From: Scala, Mary Joy
Sent: Thursday, May 30, 2013 5:12 PM
To: McHugh, Kathy
Cc: Galvin, Kathy; Tolbert, Jim
Subject: Design comments - 210 8th St NW

You asked me to provide design comments for the City of Promise house. Here are my suggestions:

CITY OF CHARLOTTESVILLE SINGLE FAMILY RESIDENCE

LOCATION PLAN
SCALE: 1/4"=1'-0"

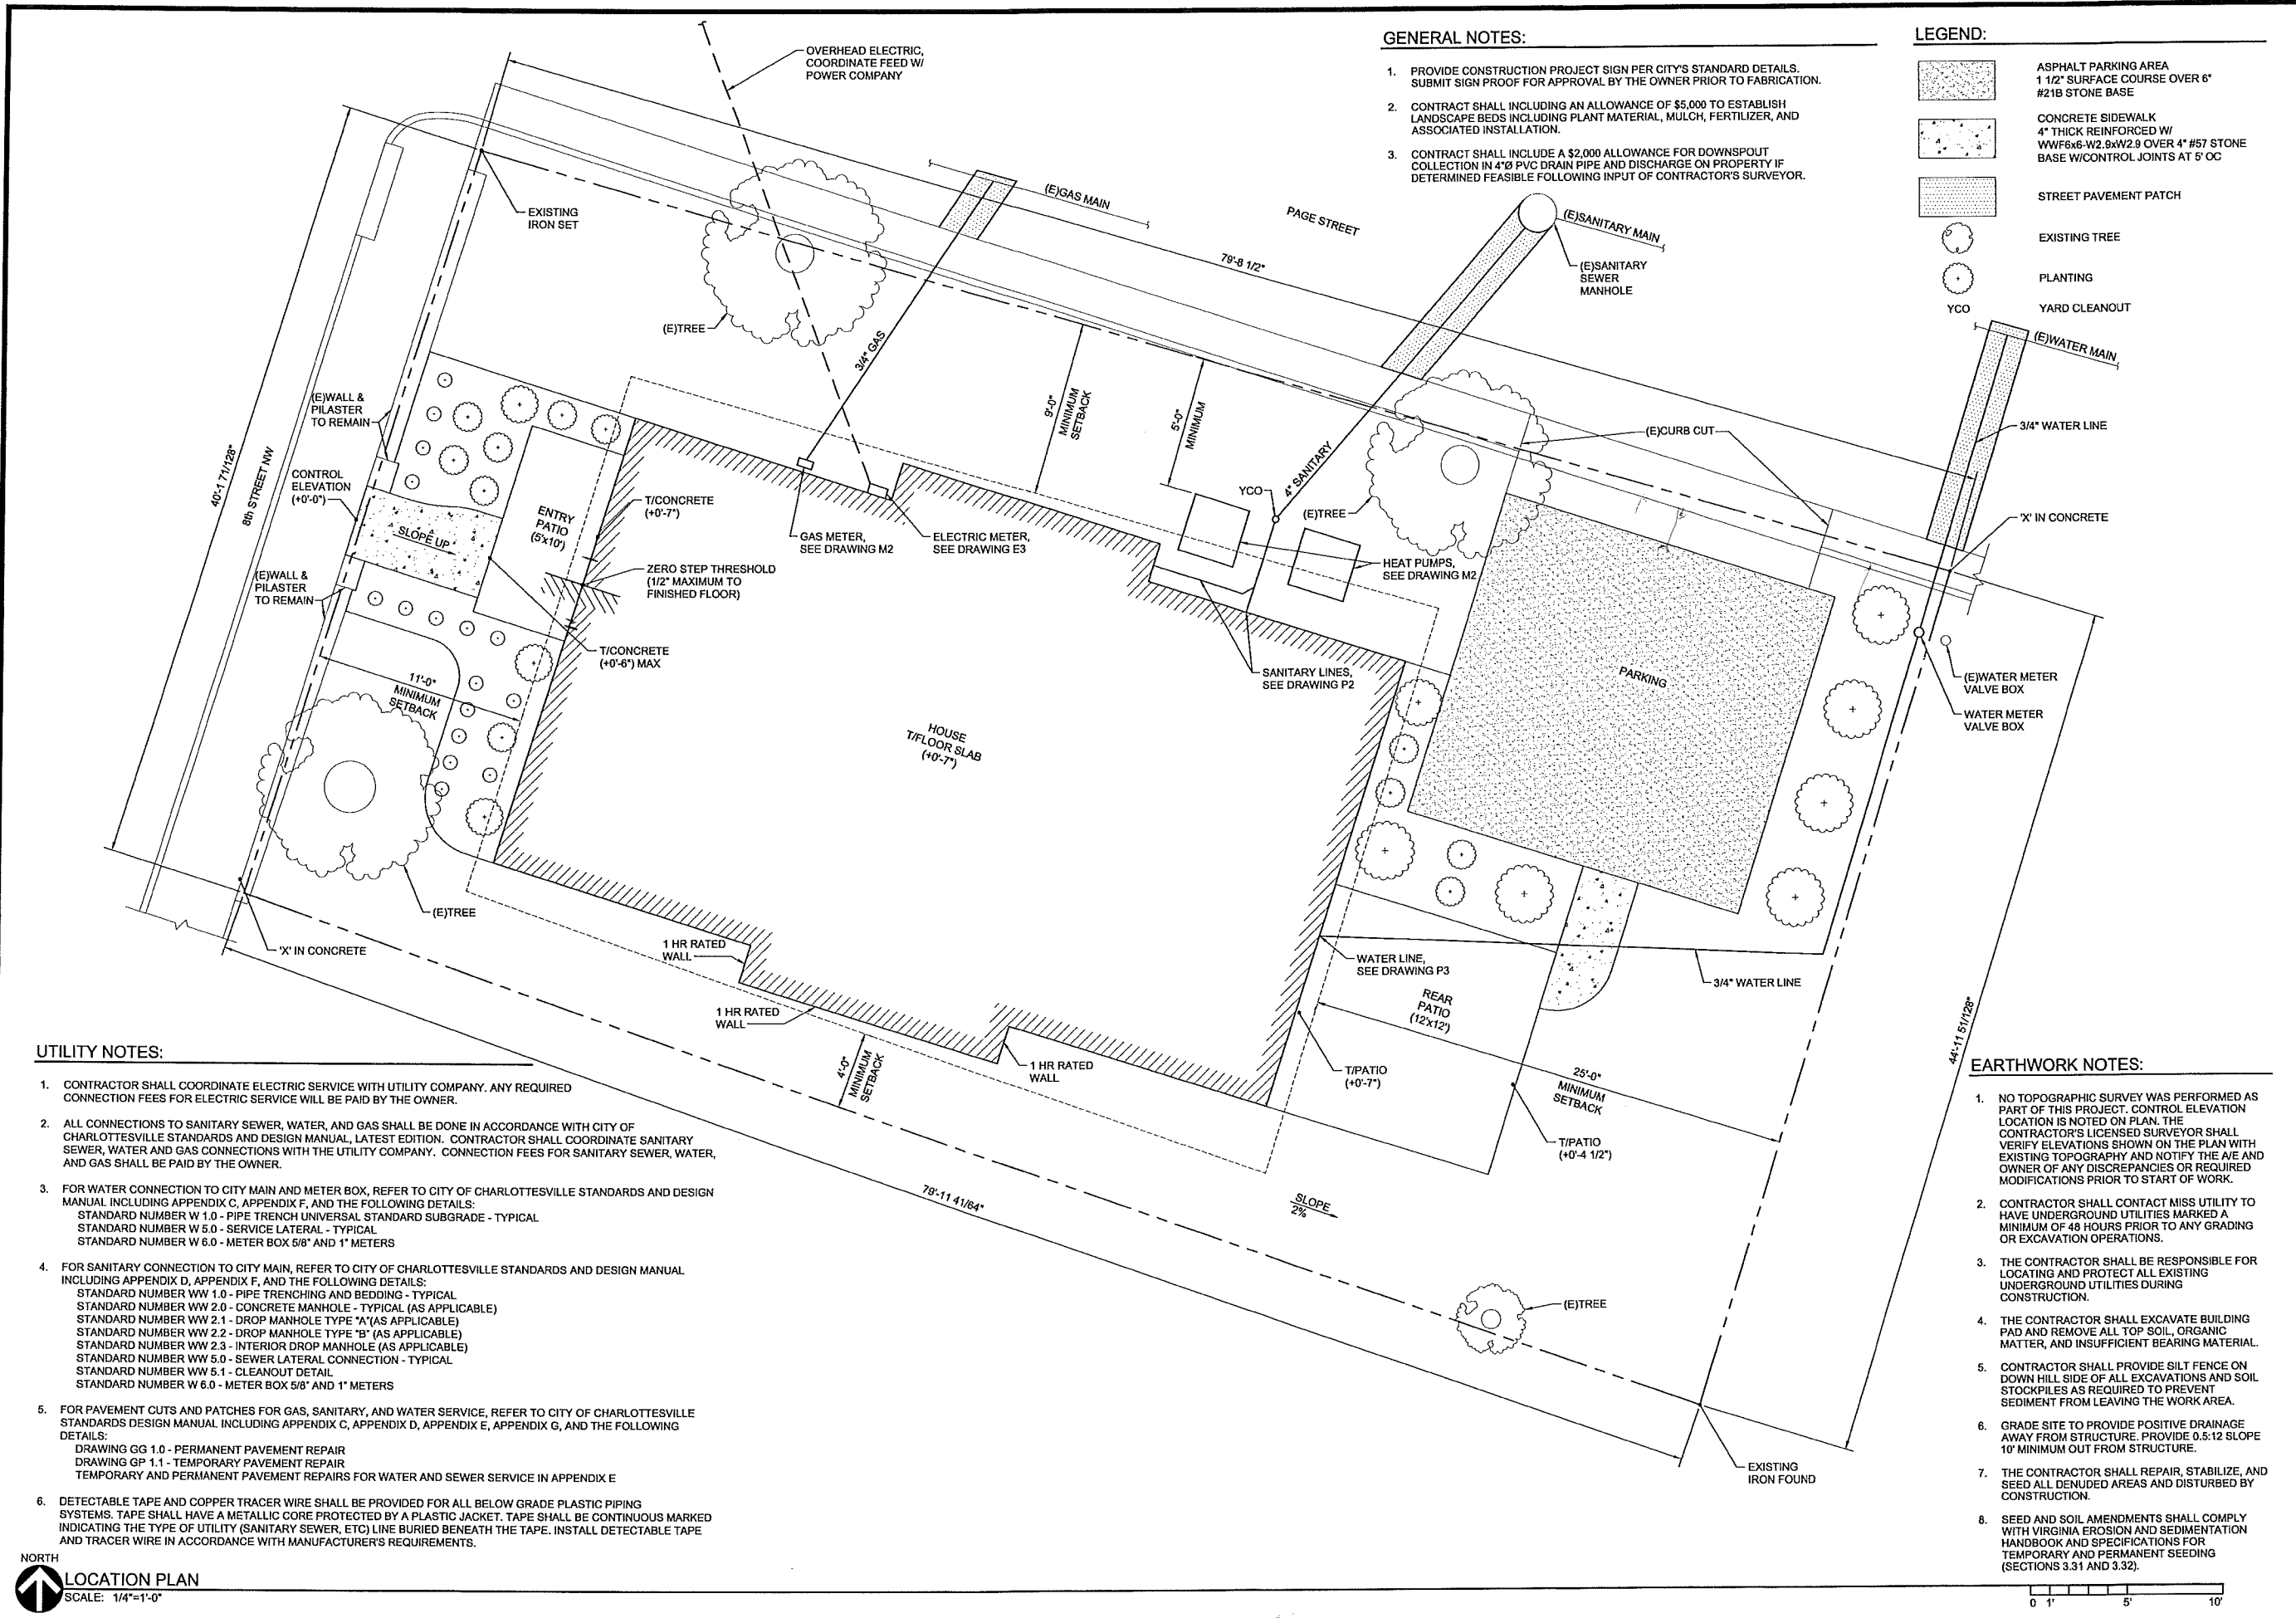
5. Check with Read Brodhead, but I believe that the mechanical units must be located outside the corner side yard setback, which looks possible, and they should be screened with a fence or shrubs. Or they could be located in the rear yard and screened from the street.

6. The site plan shows you will keep the three existing large street trees, which is good, but I believe you will be required to add a sidewalk along Page Street frontage if none exists. If the two trees must be removed for a sidewalk then they should be replaced with a large deciduous species min 2" caliper.

7. Screening the parking from the adjacent property is good.
8. I do not prefer the 16 foot curb cut with two cars having to back into the street, but cannot think of another way to reduce the curb cut width without stacking the cars.

*- Review for compatibility w/ neighborhood
- Realize that there are no design criteria
for this location*

FIRST FLOOR PLAN
SCALE: 1/4"=1'-0"

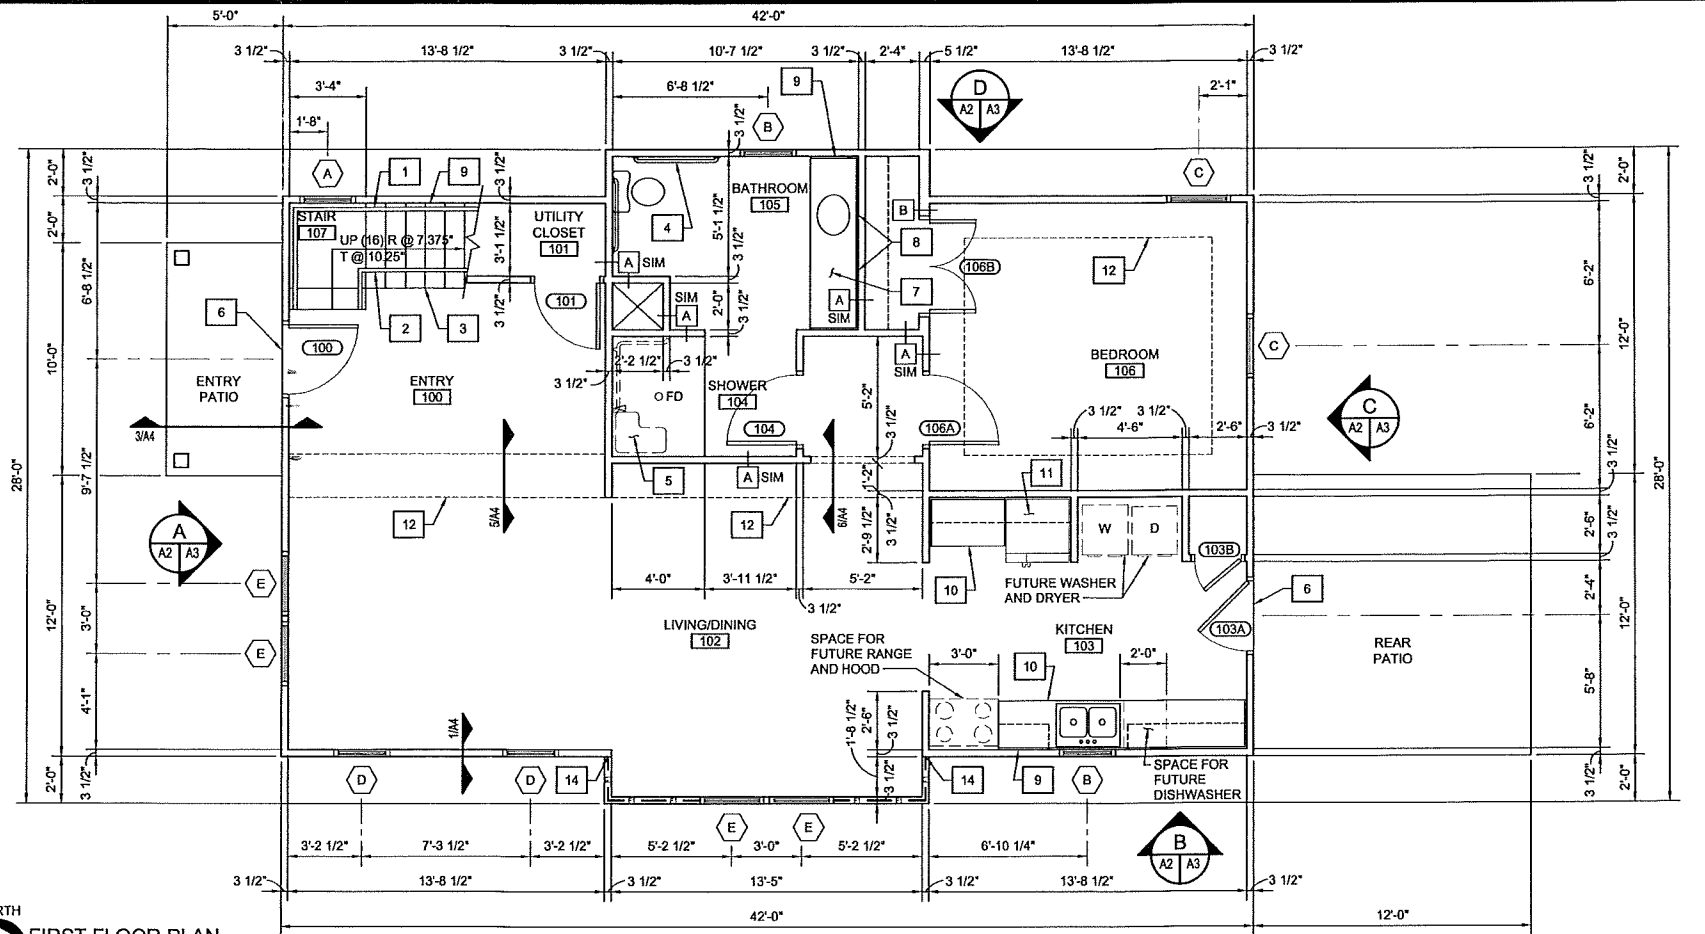
4. Regarding flipping the floor plan, you mentioned the architect had concerns about locating the gas and electrical lines on the side of the house with more windows, and concerns locating the patio where the parking is proposed. I still think it could be flipped by carefully locating the utilities, and by keeping the patio where it is now and moving the rear walkway next to the building for access. But given that Page Street is not very heavily travelled in that location, I think the current plan is probably OK. Regardless, you may want to move the rear walkway closer to the house instead of further back because people will tend to cut the shortest path from parking to kitchen door.

A FRONT ELEVATION
SCALE: 1/4"=1'-0"

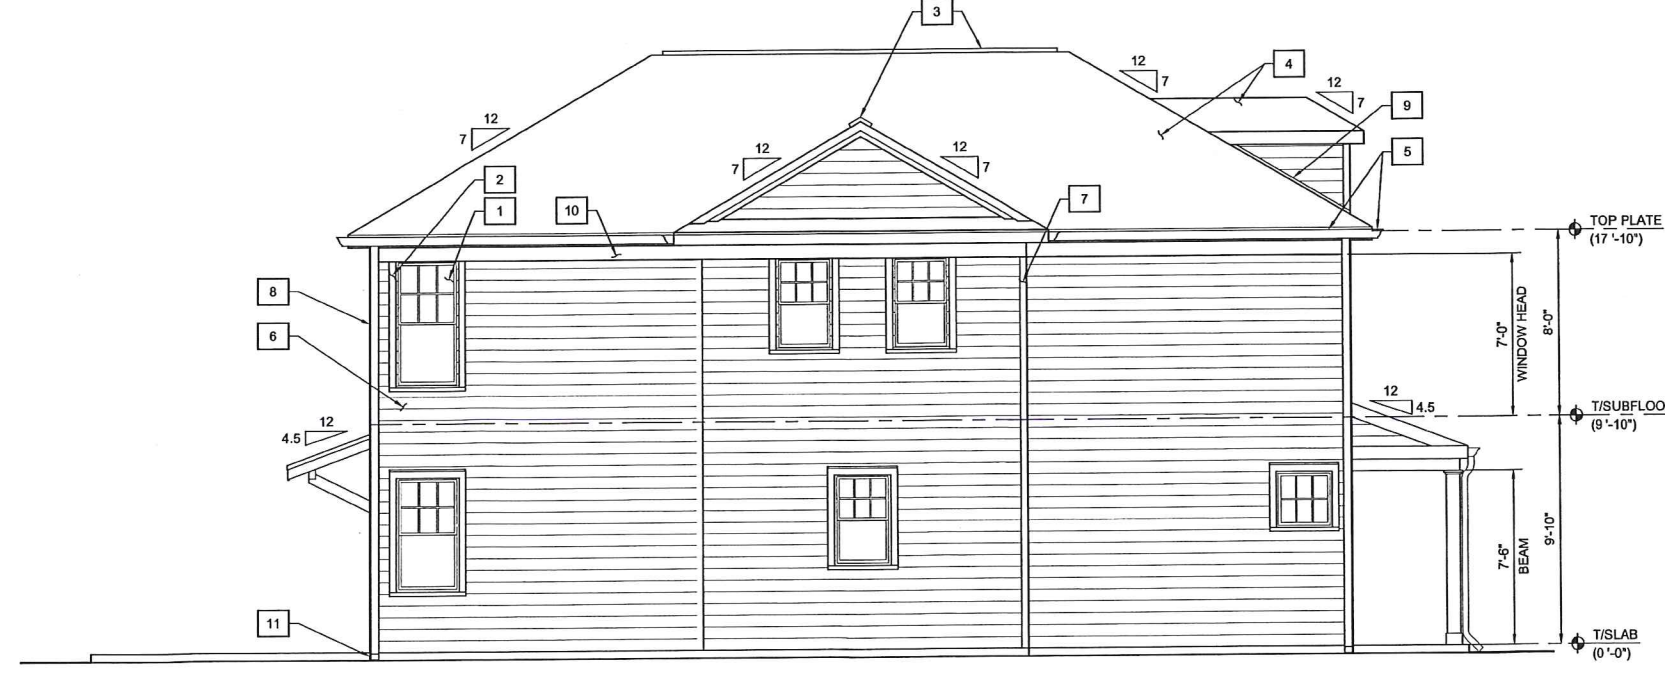
1. I understand that the front patio has to be accessible, but I would suggest adding a 36" high wood picket railing to add privacy and make it look like other porches in the neighborhood; a usable porch is a very important feature.

2. Thank you for preserving the original front site wall and pilasters. Unfortunately the front door centered on the porch does not line up with the site wall opening or the front walkway. However, if you move the front door about 2 or 2-1/2 feet to the far right side of the porch it would line up with the site wall opening and the walkway, which could then be straight instead of having the slight curve. (If you move the front door you will need to also move the upstairs window the same distance to line up vertically.) Moving the door and adding railing would make a big difference.

3. Aluminum clad windows are preferable because they are more sustainable and longer-lasting than vinyl clad. If simulated divided lights are necessary then they should be applied to the exterior and not be the "grids between the glass" or interior snap-in type. (Or using a one-over-one window configuration instead would be fine.)

9. The fiber-cement lap siding with wood composite trim is appropriate. The color scheme for the house should be bright and cheerful like others in the neighborhood.
